**Subject:** Specification of service life limitations for the brake hoses of the hydraulic wheel brake

**Applicability:** **ASW 24;** all models; Type-Certificate LBA 366; all serial numbers  
**ASW 24 E;** Type-Certificate LBA 859; all serial numbers

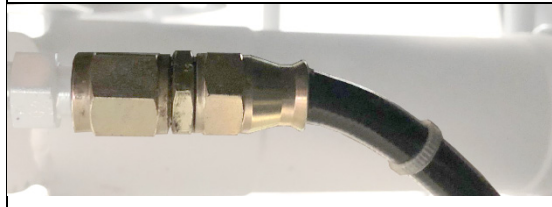
<p>Brake hoses of the <b>old type</b> made from rubber material, identifiable by the shown fitting shape and the textile fabric wrapping of the hose.</p>
	<p>Brake hoses of the <b>new type</b>, identifiable by the shown fitting shape.</p>

Brake hoses of the **old type**: This brake hose has to be exchanged in regular intervals of 6 years. If the brake hose is in good condition, it is not necessary to exchange the hose. Operation on condition requires the inspection of the hose for proper condition at least every 100 h.

Brake hoses of the **new type**: This brake hose has no service life limitation (on condition).
